TPS6590377

File	<Title>		Rev
Size	Document Number	V0.1	
Date:	Wednesday, May 15, 2019	Sheet	35 of 116

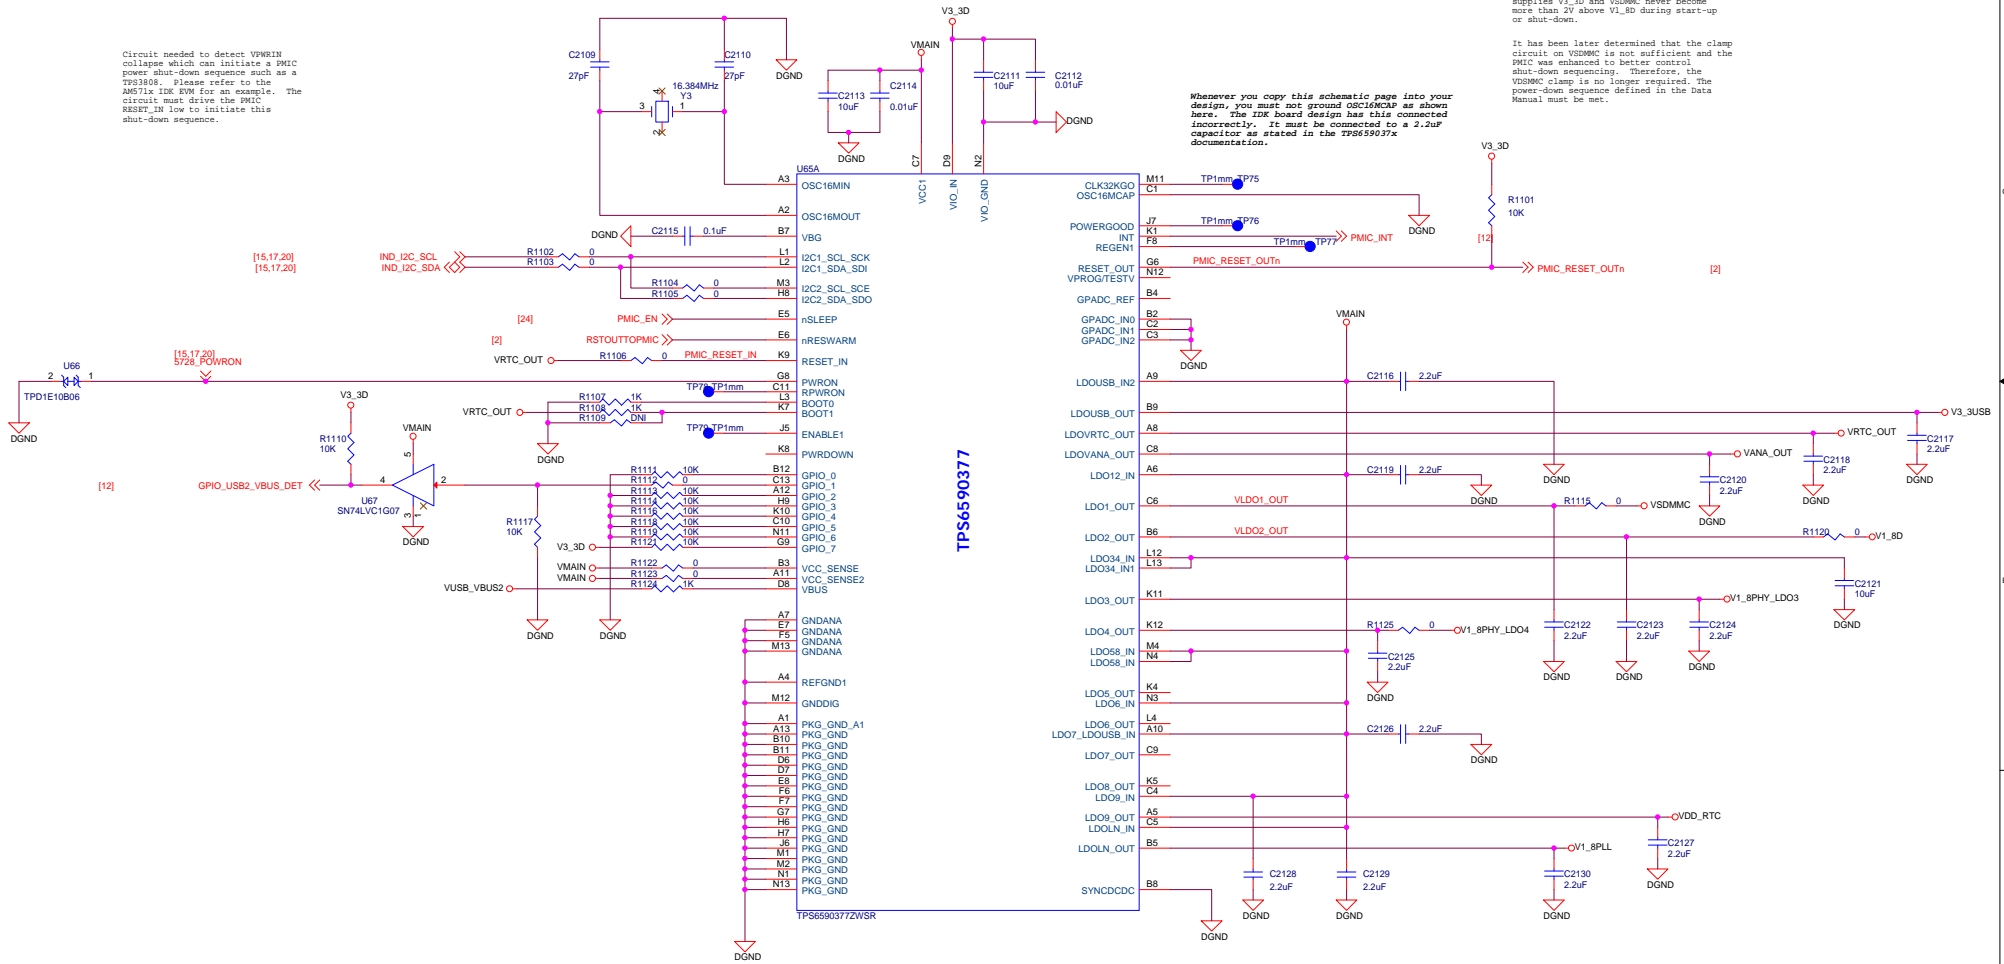
Sufficient capacitance needed to hold up VMAIN (over 2.7V) for at least 1ms after power supply shut off. AMS76x device will be in POR reset. This will allow the PMIC to properly execute its power-down sequence.

Circuit needed to detect VPMIN collapse which can initiate a PMIC power shut-down sequence such as a TP3806. Please refer to the AMS71x I2C RVW for an example. The circuit must drive the PMIC RESET_IN low to initiate this shut-down sequence.

Clamp circuits added to guarantee the 3.3V supplies V3_3D and VSDMMC never become more than 2V above V1_8D during start-up or shut-down.

It has been later determined that the clamp circuit on VSDMMC is not sufficient and the PMIC was enhanced to better control shut-down sequencing. Therefore, the VSDMMC clamp is no longer required. The power-down sequence defined in the Data Manual must be met.

Whenever you copy this schematic page into your design, you must not ground OSC16MCAP as shown here. The I2C board design has this connected incorrectly. It must be connected to a 2.2uF capacitor as stated in the TPS659037x documentation.
